STAFF REPORT 03-10-2021 MEETING

ADDRESS: 1444-1448 BROOKLYN, 1259 LABROSSE, 1309 LABROSSE

HISTORIC DISTRICT: CORKTOWN

SCOPE: REHABILITATE EXISTING PARKING LOT, ESTABLISH NEW PARKING LOT TO INCLUDE ADDITION OF CURB CUTS

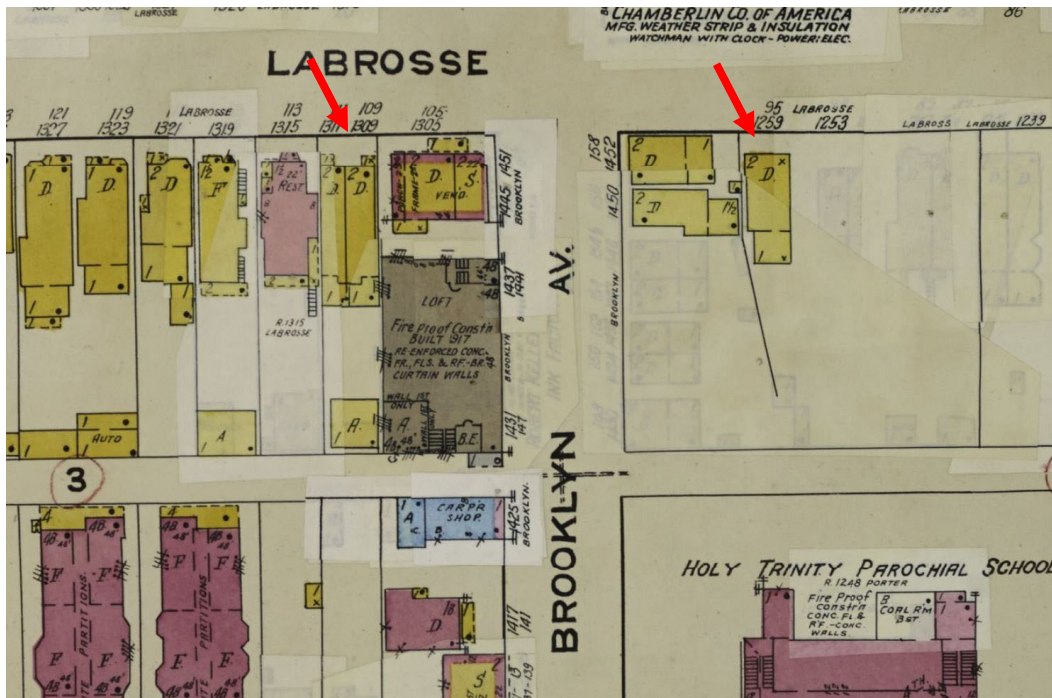
- The curb cut at 1259 Labrosse is immediately adjacent to the sidewalk serving the adjacent school/community space. There are two street trees at either side of the proposed curb cut location, which are not described on the site plan. The tree to the west is a mature specimen.

- The curb cut through to Labrosse from 1259 Labrosse be eliminated from the design
- New street trees to be an appropriate non-invasive species acceptable to historic landscape staff
